Proposal for the 01 series of amendments to Regulation No. 134

Submitted by the expert from the Netherlands *

The text reproduced below was prepared by the expert from the Netherlands, aiming to update the official document ECE/TRANS/WP.29/GRSP/2020/10 in order to include the recommendations with regard to place and dimensions of the labels on vehicles. The modifications to the current text of ECE/TRANS/WP.29/GRSP/2020/10 are marked [in blue](#)

Model B

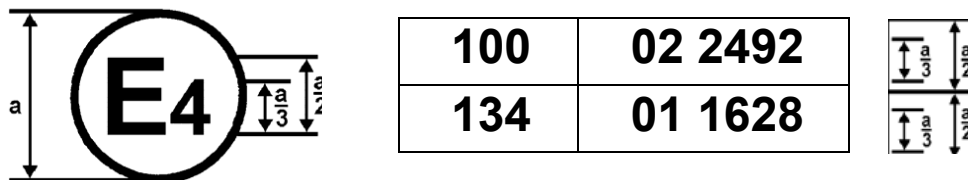
The above approval mark affixed to a vehicle shows that the road vehicle concerned has been approved in the Netherlands (E 4) pursuant to Regulations Nos. 134 and 100.* The approval number indicates that, at the dates when the respective approvals were granted, Regulation No. 100 was amended by the 02 series of amendments and Regulation No. 134 ~~was still in its original form.~~ **amended by the 01 series of amendments.”**
